ERCOUPE  
SERVICE  
MEMORANDUM

No. **18**

**SUBJECT: Engine Side Cowls  
Reinforcement of**

INSTALLATION OF GUSSET PLATE AND WASHER  
ON ENGINE SIDE COWL

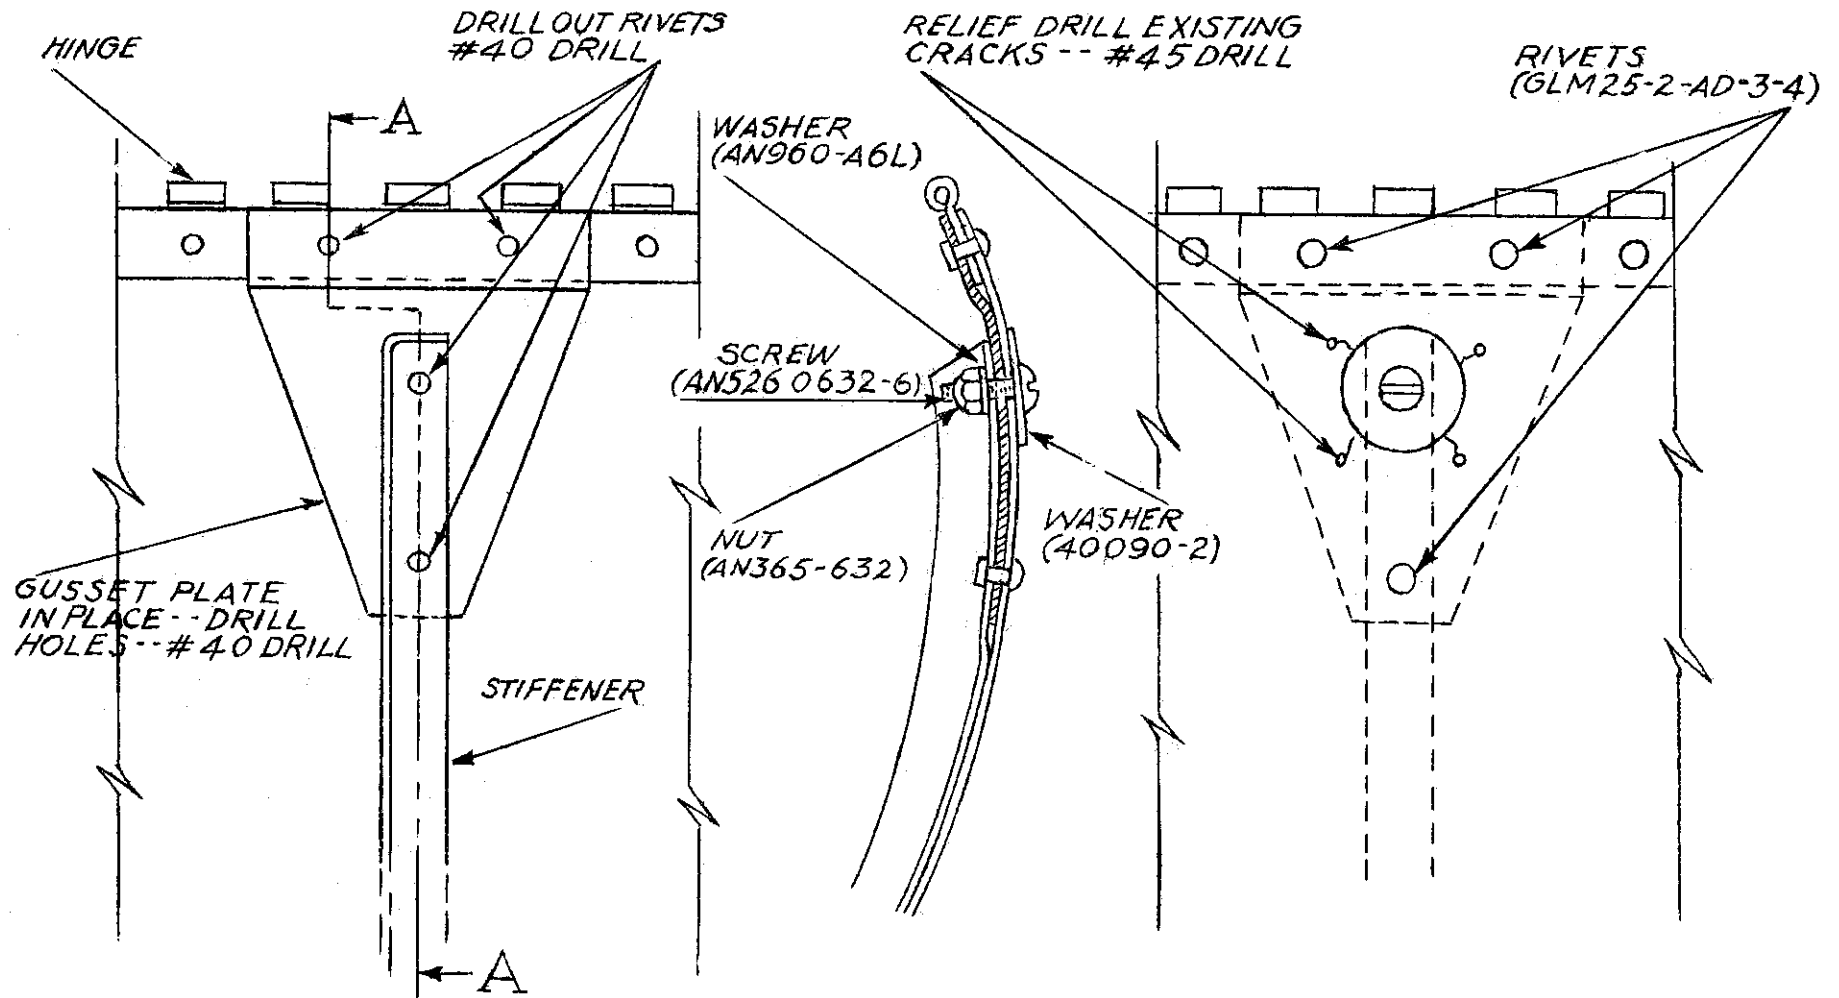
2. The change has been found necessary to prevent cracks occurring in the region of the uppermost rivet used to attach the stiffener to the side cowl. The cracks occur, we believe, as a result of the loads imposed when the cowl is opened and left to rest in the open position. The change is being made on current production, having started on Ercoupe airplane serial number 1123.

B. Drill out four rivets. Use No. 40 drill.

1. Drill out two rivets, holding hinge, immediately above stiffener.
2. Drill out first two rivets in top of stiffener.

C. Existing cracks should be relief drilled to prevent further cracking.

1. Drill holes at ends of cracks with a No. 45 drill.

D. Locate gusset plate and rivet in place.

1. Slide gusset plate under stiffener with wide end over hinge.
2. Drill holes in plate at points where rivets were removed from hinge and stiffener. Use No. 40 drill.
3. Rivet gusset plate, on hinge (two rivets) and at second hole from top of stiffener (1 rivet).
4. Install large washer, bolt, small washer and self-locking nut, over first hole in top of stiffener. Large washer on outside of cowl. Draw nut tight to assure lock.
5. Shape large washer to fit flush against surface of cowl flap.
